GPS and BT/WiFi Antenna Location

# WiFi Antenna Photos

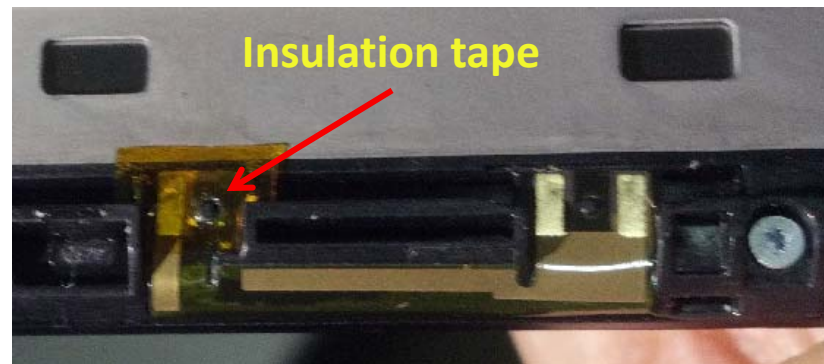
Before Class 2 Change, the Insulation tape was not assembled. This insulation tape is added at Class 2, and it makes the same distance between antenna and contact pin to get consistent performance.
